National Grid ESO
Faraday House
Gallows Hill
Warwick
CV34 6DA

Dynamic Moderation (DM) and Dynamic Regulation (DR) Terms and Conditions

Amendment of EBR Article 18 mapping to update for revised Dynamic Moderation and Dynamic Regulation Terms and Conditions

Summary of responses and key themes from the consultation responses and NGESO comments. For responses provided on the official template we have only included the specific questions the provider responded to, all other questions should be assumed as “no comment” from the provider. Where providers have submitted detailed letters, or their response is very detailed on the response template NGESO has summarised the response into key themes.

Response Energy Volume as Currently Defined

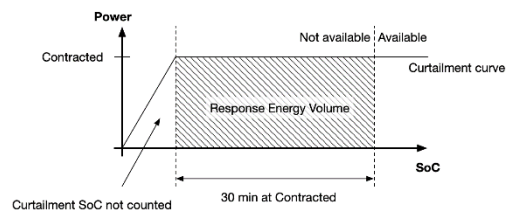
The stored energy with which an energy limited asset must start the service and maintain a level above for availability (the Response Energy Volume) has been defined in energy only. This assumes that an energy limited asset can deliver any power up to its contracted power throughout the full stored energy range. For battery storage assets this assumption is not valid, they will curtail to zero power as the stored energy approaches zero. For most of these assets the ability to deliver full power stops while there is a significant volume of energy stored, up to 10% of the total storage. This means that as the Response Energy Volume is currently defined, using energy only, the duration the asset could deliver the contracted power could be much less than the required 30 minutes.

We suggest that the definition of Response Energy Volume is adjusted to explicitly exclude any energy volume for which the contracted power cannot be delivered. For example a clause could be added as follows:

The **Response Energy Volume** excludes any energy for which the **Contracted Quantity** cannot be delivered.

Thank you for your feedback. It is the duty of service providers to maintain their SoE at a level that the full Response Energy Volume could be delivered. If this means accounting for energy that is not deliverable (for the reasons you describe, or any other reason) then the service provider has the responsibility to do this. Further information on State of Energy and examples of this are provided within the Participation Guidance.

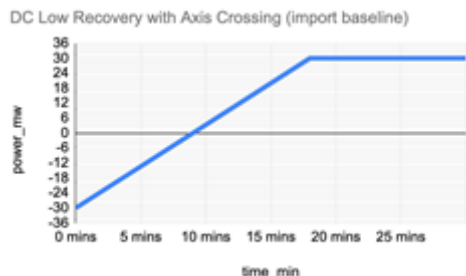
This ramp rate restrictions affect many configurations that are desirable when using the baseline to trade, e.g. a 100MW asset cannot do HighLow with a symmetric 50MW Contracted Quantity because it does not recover sufficient volume (unless the baseline in the previous SP is 0).

Current guidance assumes baselines start at 0. This may not be true if manual SoE management is occurring (or other activities such as trading).
